From: Wickham, Jerry, Env. Health
Sent: Thursday, November 06, 2014 3:13 PM
To: 'Peter Sims'
Subject: RE: Ashland Housing Project
Attachments: RO3122_Borings for Excavation Sampling_2014-11-06.pdf

ASHLAND FAMILY HOUSING
 KENT AVE. AND E. 14TH STREET
 ASHLAND, CA

**GRADING PLAN:
 CONSTRUCTION
 NOTES**

CHECKED: CW
 SCALE: 1"=20'
 SHEET NUMBER: **C-4.2**

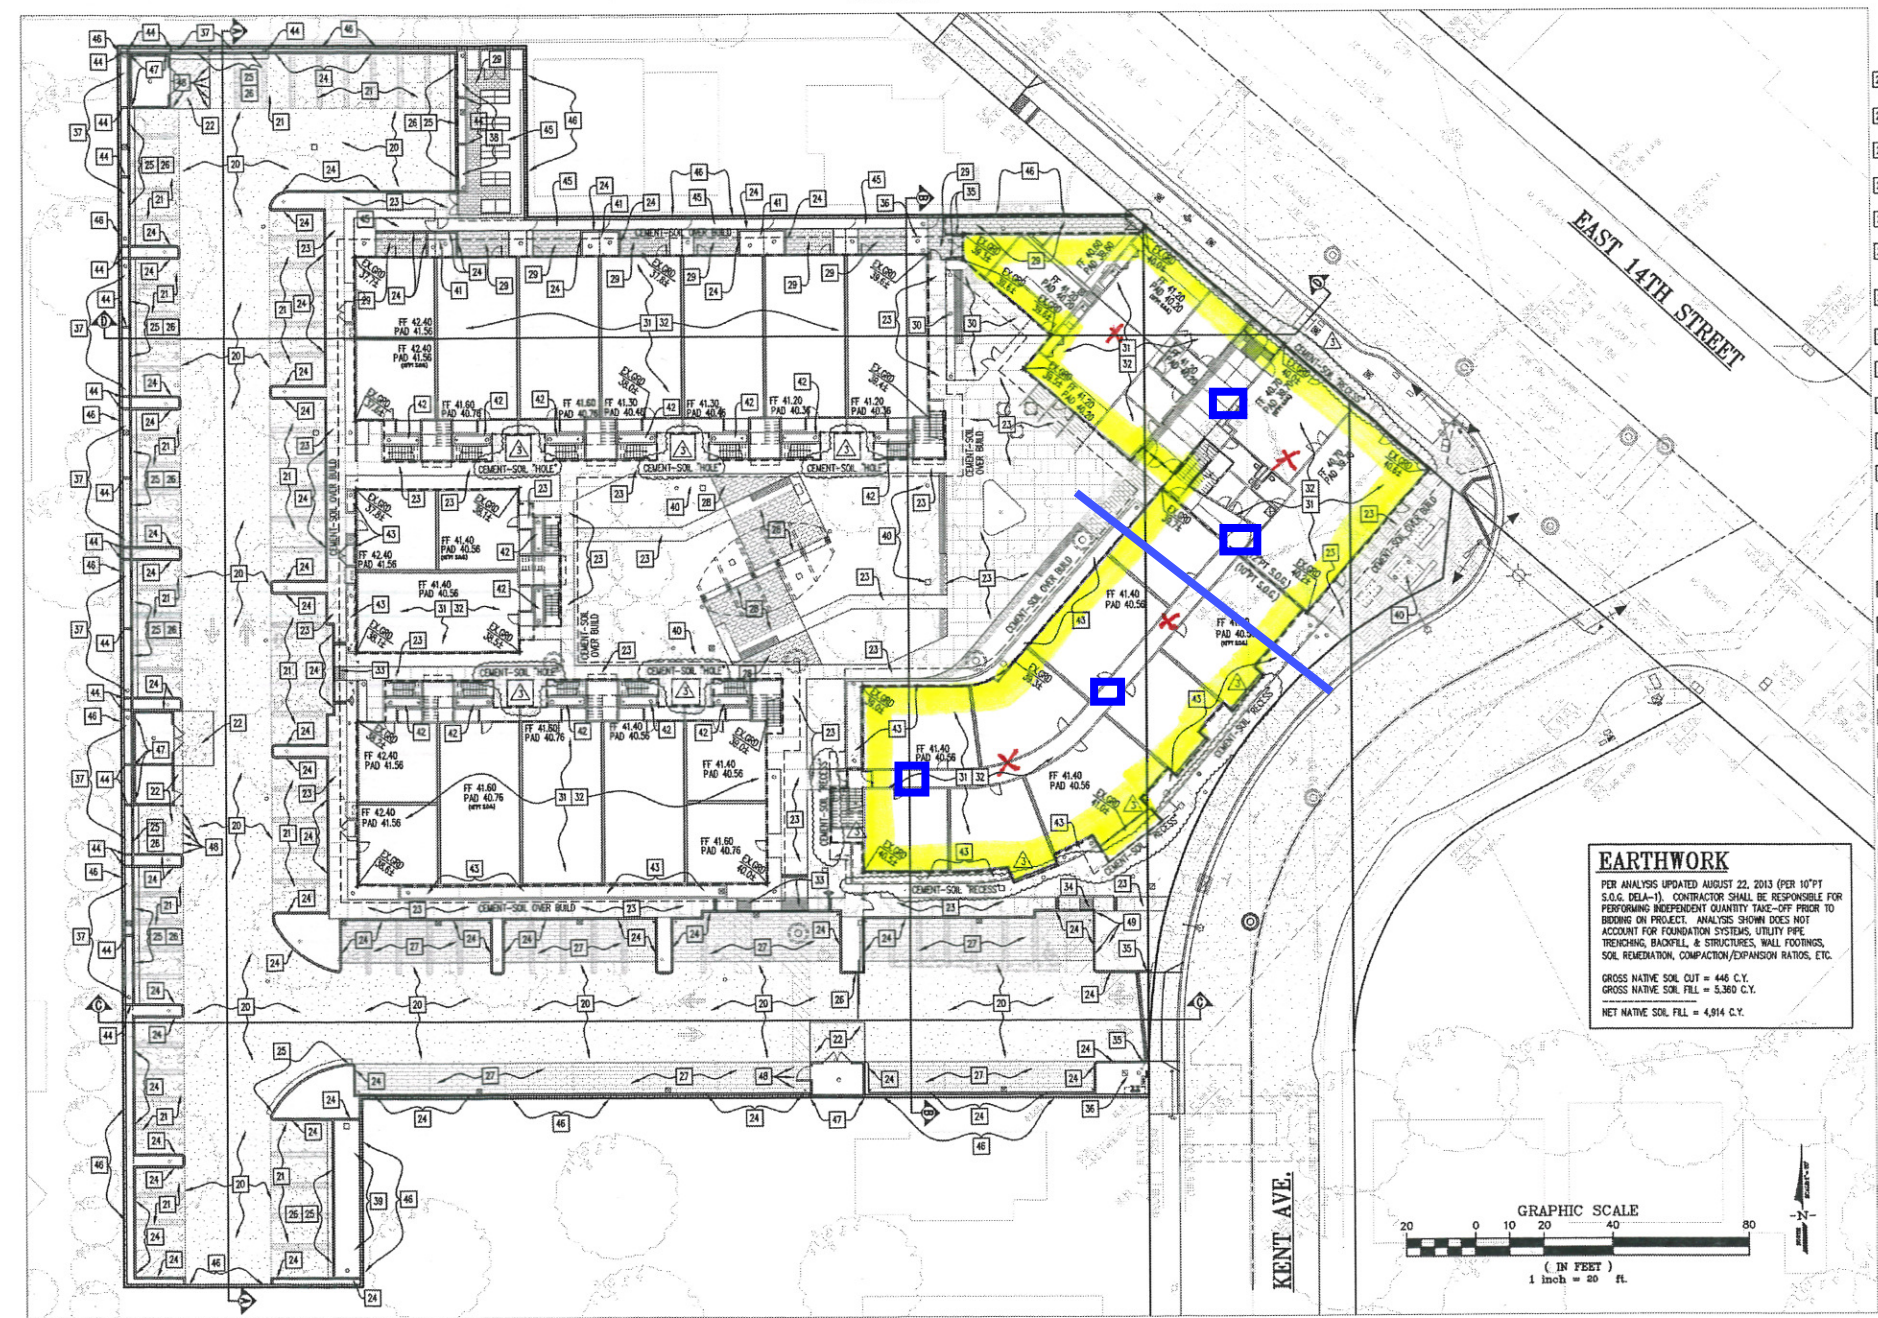
The Ashland contractor has asked me to perform additional characterization of 2,777 cubic yards of soil to be excavated beneath Building A (highlighted on the attached figure) to a depth of 5 feet bgs. We would like to sample the soil in-situ to determine if it is suitable for reuse on site or off-site waste disposal classification. Since we did not discuss in-situ sampling for soil reuse/disposal in our IRAP, I would like to perform the sampling as described below based on the DTSC Fill Guidelines (attached).

Advance four borings (shown on the attached figure) to 5 feet bgs for the collection of soil samples at 0, 1.5, 3, and 5 feet bgs in each boring.

Your proposal to conduct in-situ sampling prior to reuse of fill material from Kent Avenue will be acceptable if the number of soil borings are increased from four to eight as shown on the attached map. For compositing purposes, the area is to be divided into a southern and northern half with four borings in each half. Soil samples from the same depths in the southern half may be composited by the laboratory into four composite samples. Similarly, samples from the same depths in the northern half may be composited by the laboratory into four composite samples. Collection of one discrete sample per boring (collected from different depths in southern and northern half) is acceptable. The proposed laboratory analyses and the items to be included in the request for approval are also acceptable.
